SHEET NO. EX-1

CONCEPT SITE PLAN

OPPIDAN CAFE  
BLOOMINGTON, MN

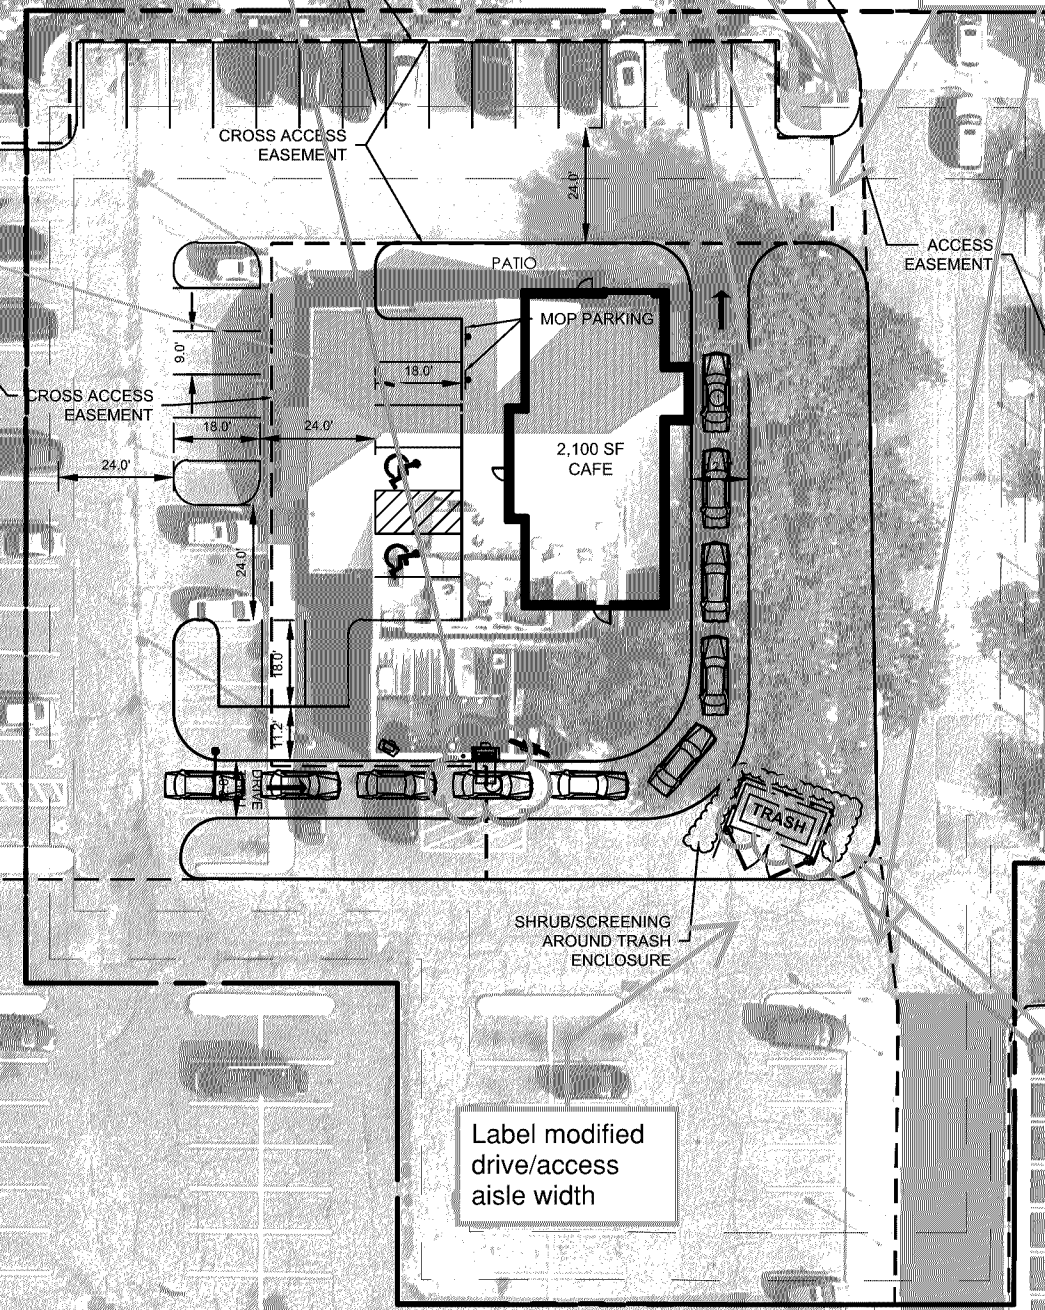
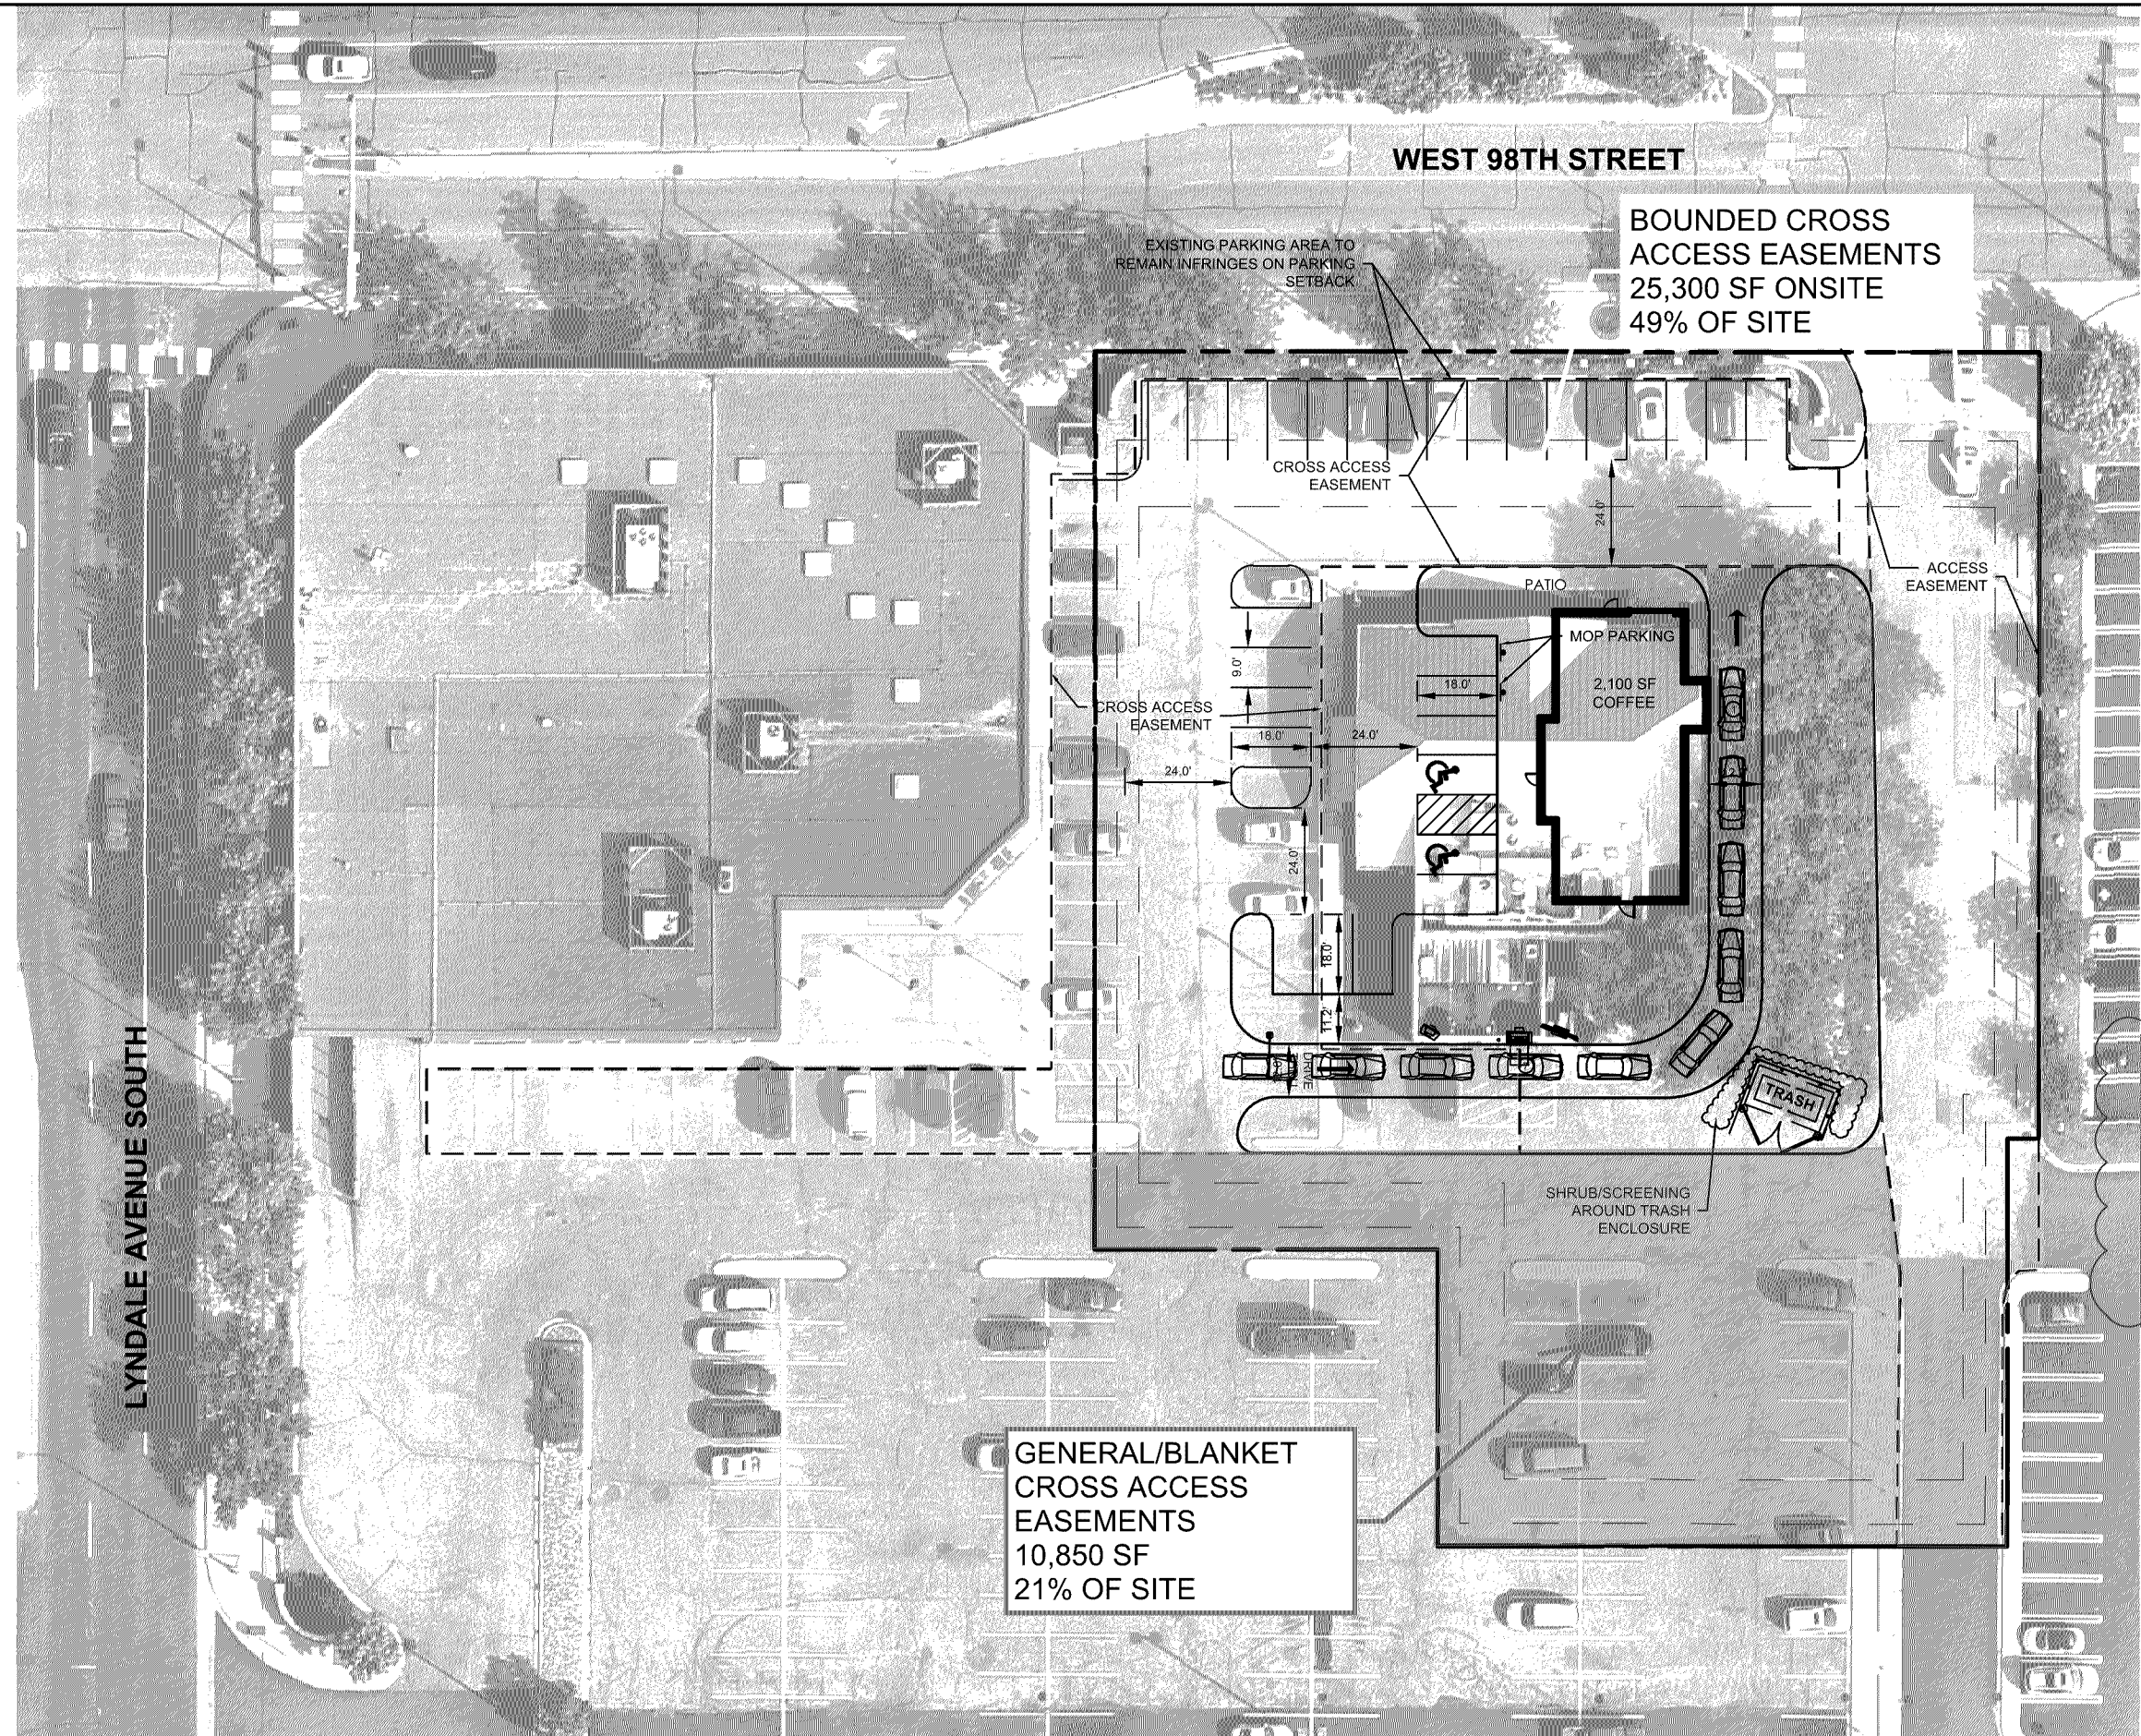
Building is required to be sprinklered per MSBC 1306.

Emergency responder radio coverage meeting the requirements of appendix L in the 2015 MSFC shall be provided throughout the property and within the structures.

Appliances/cooking producing grease laden vapors requires a hood and suppression system.

Hydrant coverage shall be provided within 50' of the FDC and within 150' of all portions of the structure.

Provide for the new structure and maintain for existing structures emergency vehicle access throughout the property.

Drive-through must have six stacking spaces from the first point of contact, which is the order board in this case. Stacking spaces must be a minimum of ten feet by 20 feet in size. See Section 21.301.05 of the City Code for drive-through standards!

North access is too close to traffic signal and driveway traffic queue. Right-in only at this north driveway is recommended as it would function more safely and without backing up the drive through. Traffic exiting the site would go around to southern drive aisle.

Show the sidewalk through the site which should remain and/or be enhanced

Trash and recycling storage must comply with Section 21.301.17 of the City Code. External trash storage is not permitted. The finish plan of the internal trash room must meet the performance standards for food service facilities.

Show sidewalk realignment and connection in this modified area.

Minimum 7' sidewalk width adjacent to parking stalls

Must meet current MN State Building Code

SAC review by MET council will be required.

Must meet MN Accessibility Code

Label modified drive/access aisle width
